## Update to Field Safety Notice Claria MRI™ CRT-D SureScan™ and Amplia MRI™ CRT-D SureScan™ Software Update

May 2017

Medtronic reference: FA747

**Figure 1a:** Strip Chart Printout showing updated Software Version in the upper right corner

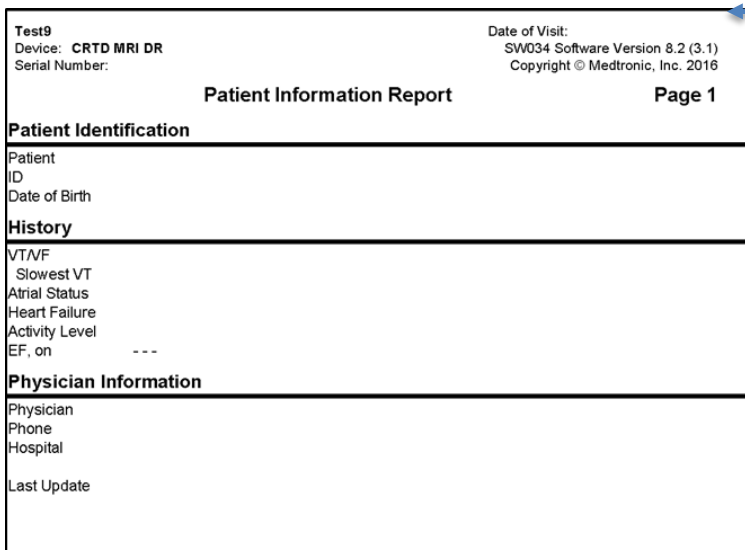
- Generate a Strip Chart, Full Size or PDF printout of the Parameters screen
- Verify the Software Version indicates "SW034 Software Version 8.2" (see arrows - Figure 1a and 1b)

If the software model does not indicate SW034 Software Version 8.2, the patient's device will need to be interrogated with a programmer that has been installed with the updated software.
